Proposal for corrigendum to UN GTR No. 4

(ECE/TRANS/180/Add.4/Amend.3)

I. Proposal

Figure 12

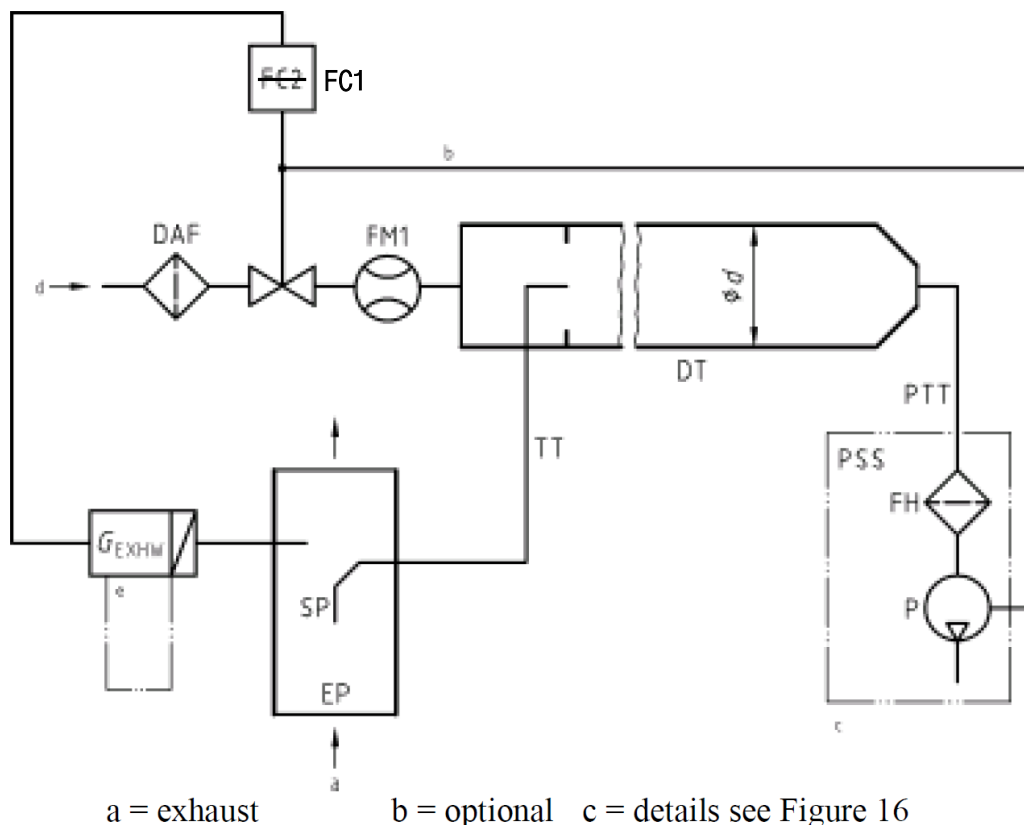
Annex 3, paragraph 2.1. Figure 12, *amend to read:*

9. Annex 3, paragraph 2.1.

In the text, the flow controller is represented by “FC1”, whereas in Figure 12, it is “FC2”.

Therefore, it is necessary to correctly set “FC1” in Figure 12.
